IMPORTANT SAFETY RECALL
Airstream Interstate Touring Coach
NHTSA 24V-432

Operation code: TCSBR8932100

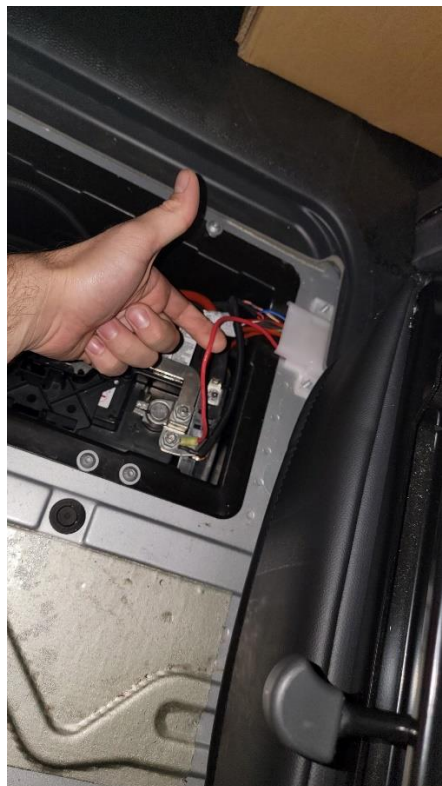
4. Identify the 12-gauge red wire connected to the Positive terminal as shown.

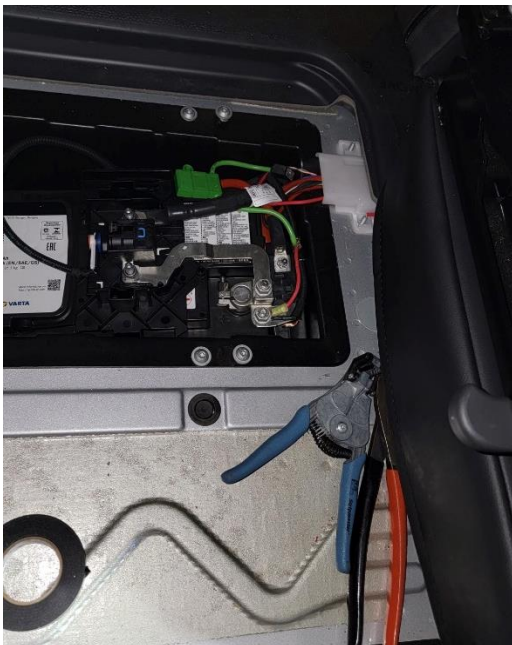
5. Cut the power wire leaving enough room for splicing. Splice in the fuse harness using two Wago connectors. After installing the harness, please insert the 20amp fuse.

6. Ensure the wire connections are not loose and route the wire and fuse holder so that the protective cover can be reinstalled.
